ADDENDUM NO. 1

PROJECT: Gum Springs Water System Improvements – Contract 1
Paint and Repair 50,000-Gal Elevated Water Storage Tank
Arkadelphia, Arkansas

ITEM #3: Appendix C – Tank Details – Sheet No. 4 – Electrical Details

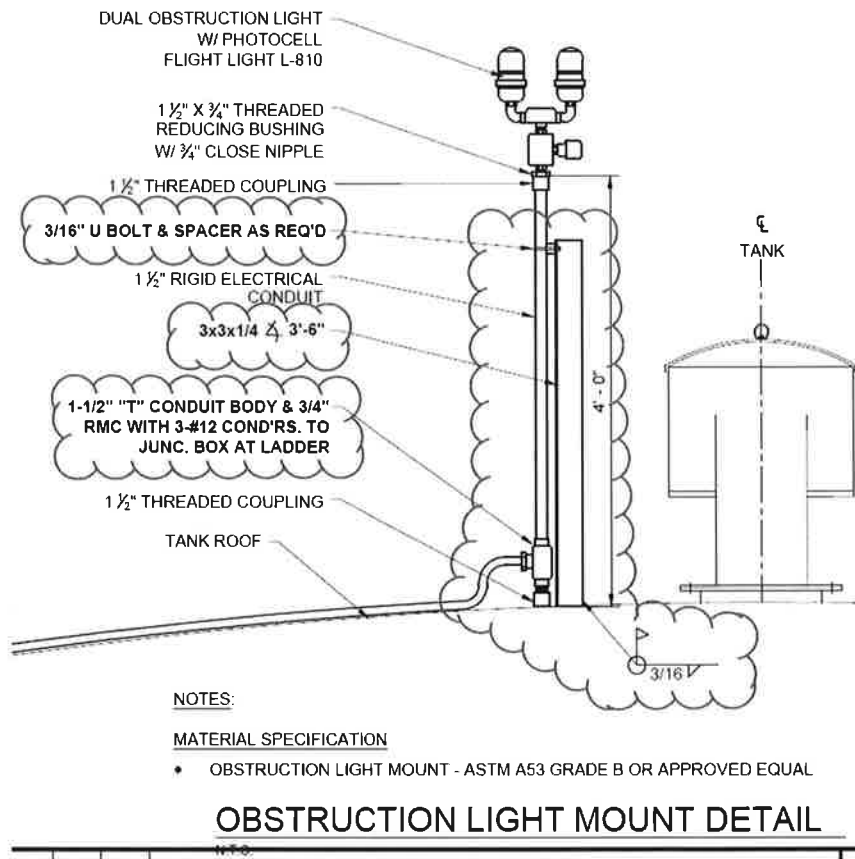
Replace the Obstruction Light Mount Detail with the following detail, Attached:

A support bracket was added for the dual obstruction light. The support bracket to be painted in accordance with the exterior coating system for the tank as specified in section 099000.
